REMARKS

The applicants have studied the Office Action dated August 27, 2003, and have made amendments to the claims. It is submitted that the application, as amended, is in condition for allowance. By virtue of this amendment, claims 1-11 and 21-23 are pending. Claims 1 and 8 should be amended, and new claims 21-23 should be added. Consideration and allowance of all of the claims in view of the above amendments is respectfully requested.

FIG. 2

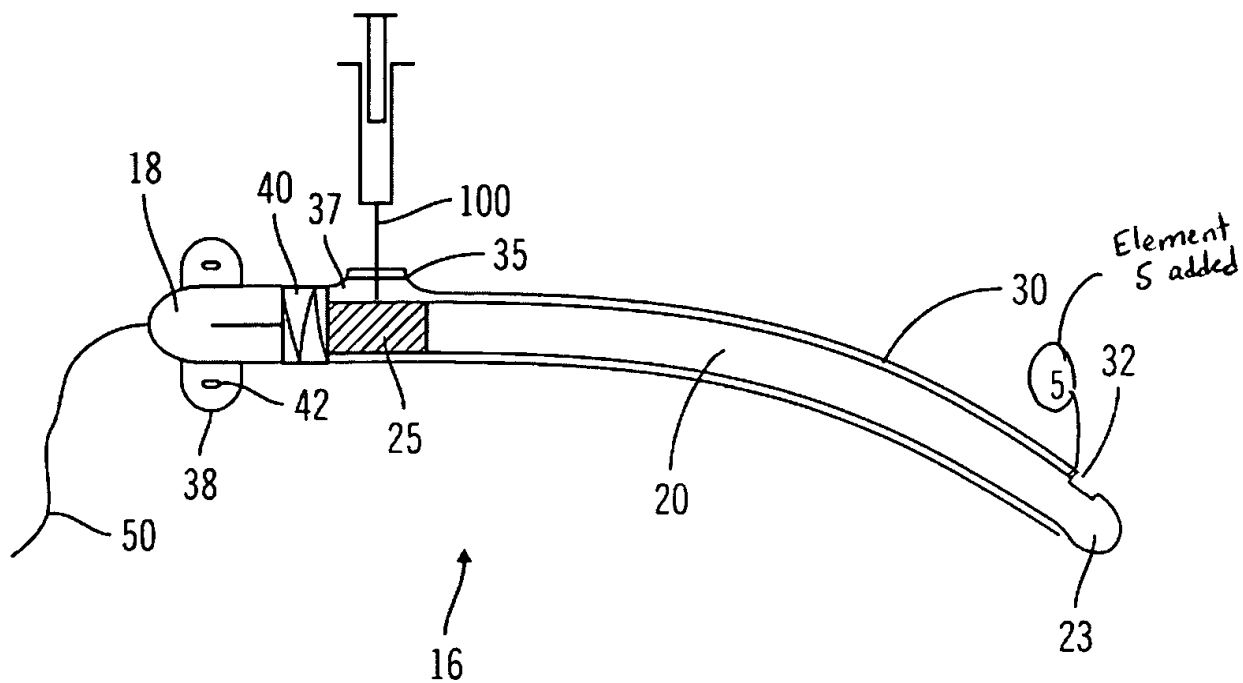
The drawings were objected to under 37 CFR 1.83(a) because the Examiner believes that the limitation found in claim 5 was not shown in the drawings. Moreover, claim 5 was further objected to under 37 CFR 1.75(d) (1) and MPEP § 608.01(o) for failing to provide proper antecedent basis for the claimed subject matter (i.e. there is no disclosure of the subject matter of the one-way valve). These objections are respectfully traversed.

Figure 2 has been amended to include element 5 (i.e. the one-way valve). Moreover, antecedent is found in the specification for the one-way valve in paragraph [0022], which states: "around the sensor tip 23, the flush sleeve 30 contains a small orifice 32, which comprises a one-way valve 5, to allow fluid to spray off the sensor tip 23" (emphasis added). Accordingly, it is respectfully submitted that the objection to the drawings and the objection under 37 CFR 1.75(d) (1) and MPEP § 608.01(o) are overcome and should be withdrawn.
